3. Highland Bluff Subdivision Quint Addition

KPB File 2025-120

**ITEM #3 - PRELIMINARY PLAT
Highland Bluff Subdivision Quint Addition**

KPB File No.	2025-120
Plat Committee Meeting:	September 8, 2025
Applicant / Owner:	Janelle Kara Quint and Kenneth David Quint / California
Surveyor:	Jason Young / Edge Survey & Design, LLC
General Location:	Pavlof Dr. off Cohoe Loop Road

HIGHLAND BLUFF SUBDIVISION QUINT ADDITION

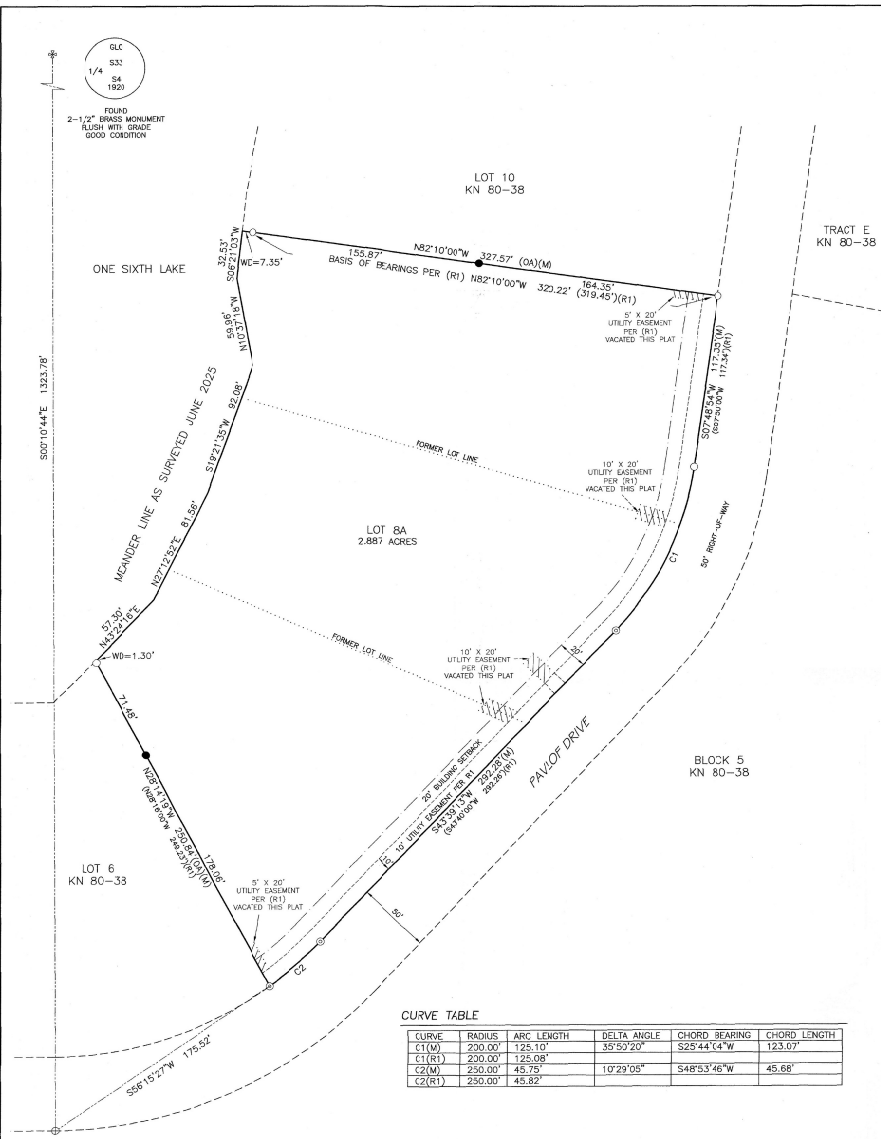
Carry forward plat notes 4, 5, 7 & 9 from the parent plat KN80-38

In the legend, revise the line label of 'Former lot/easement line' to "Former Anchor Easement" as per KN80-38.

The hatching label needs changed to anchor easement instead of utility easement in the legend.

Add a plat note that the utility easement shown 'vacated this plat' were granted approval for vacation at the Planning Commission meeting of September 8, 2025.

Modify the KPB File No to 2025-120
Change the recording district to Kenai.

Tract E needs Block 5 added and needs depicted lower on the drawing.
Block 4 needs added to the two parcels north and south.

Majority of plat is located in *Discharge Slope* and a small portion in the west edge is in *Depression*. These areas should be noted and rather than hatching, a line showing the division should be added.

Block 4 needs added to the parcel.label

Wetlands

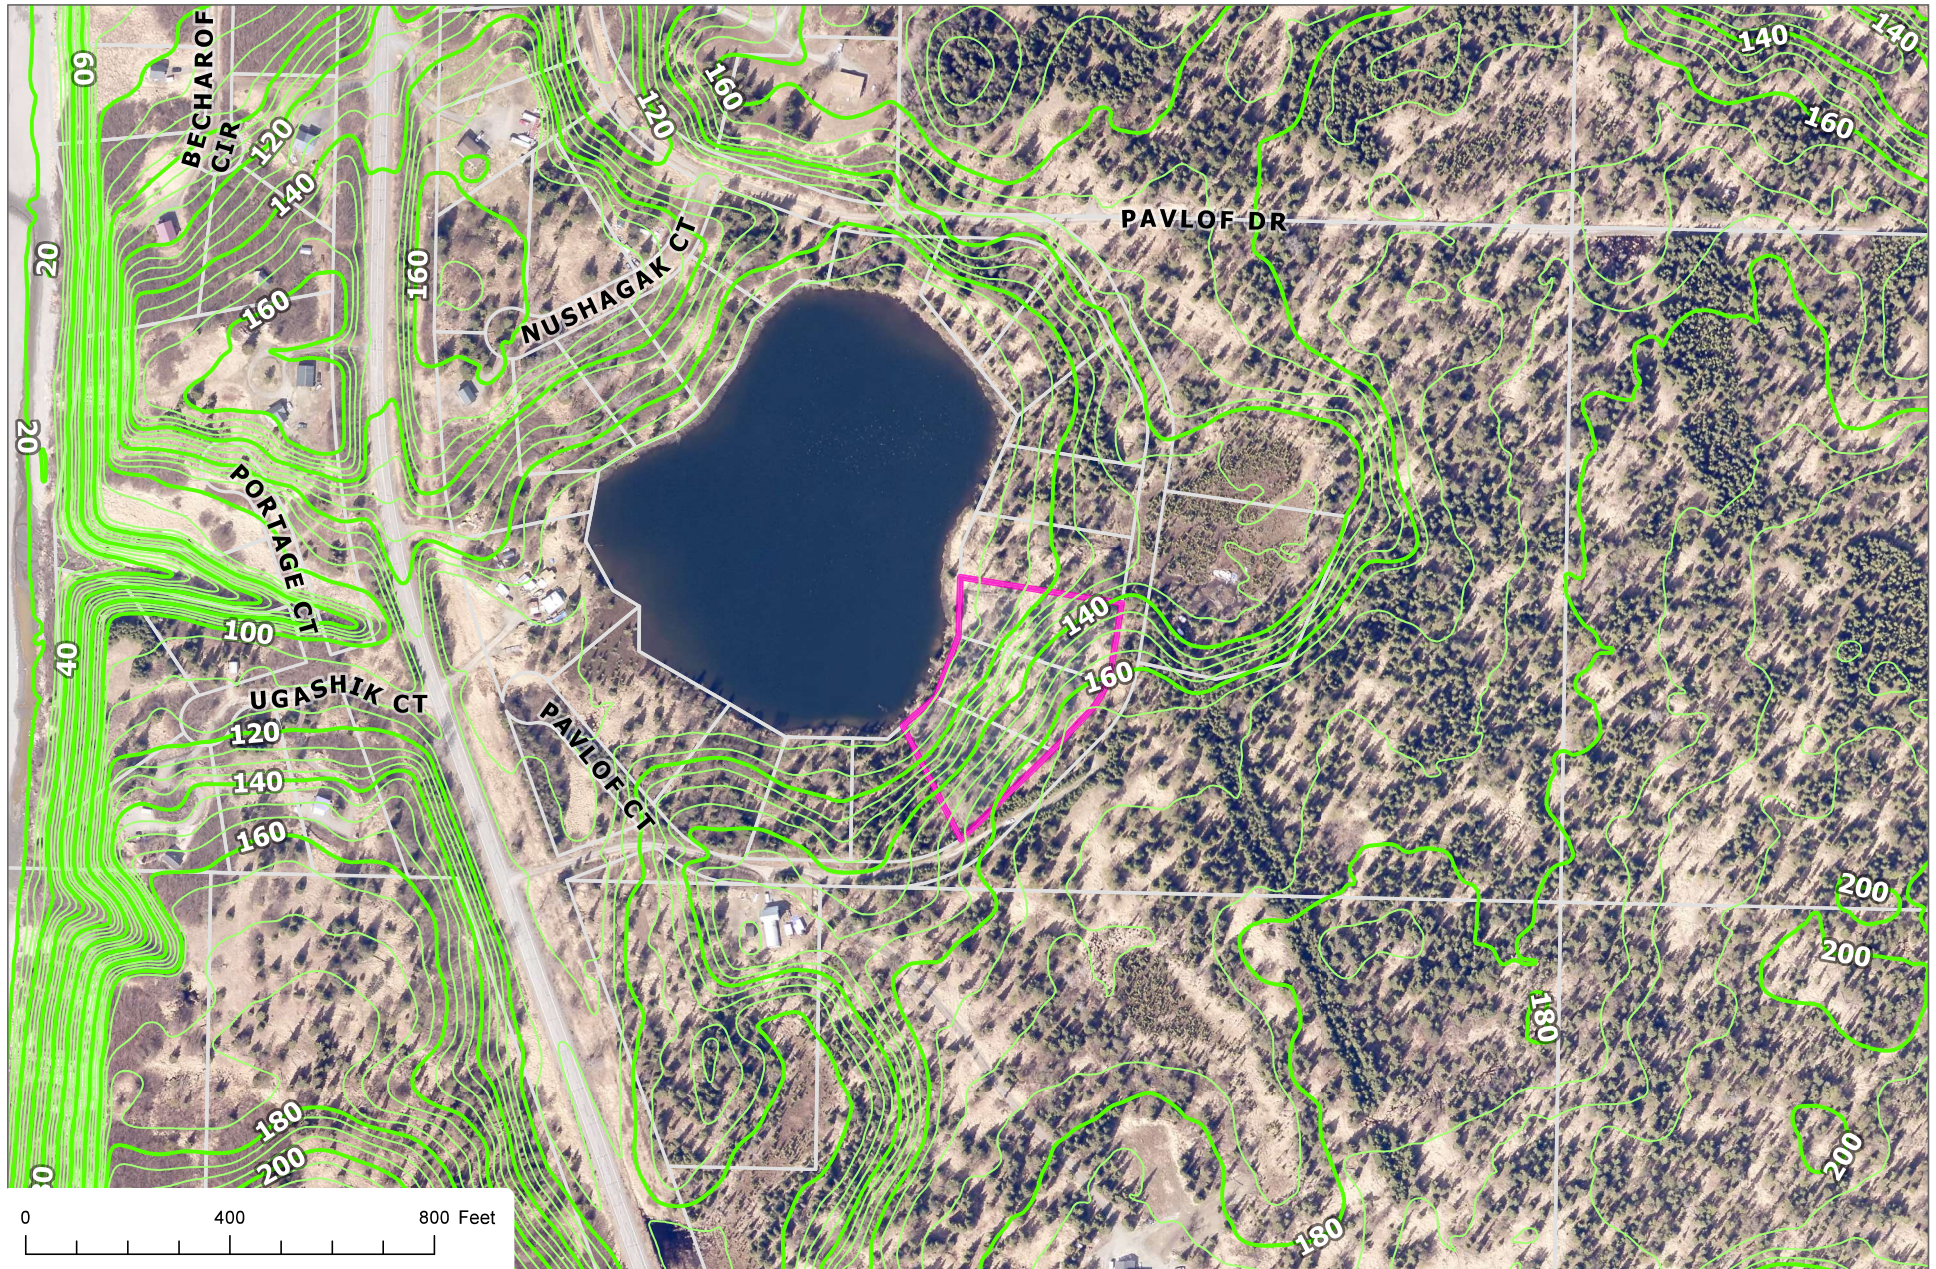
The KWF Wetlands assessment indicates the majority of the plat to be identified as Discharge Slope with portions near the lake being labeled as Depression. **Staff recommends** the surveyor add a note to the drawing and a line identifying the line between the two wetlands on the plat rather than hatching the entire plat. The appropriate wetlands note is located on the plat.
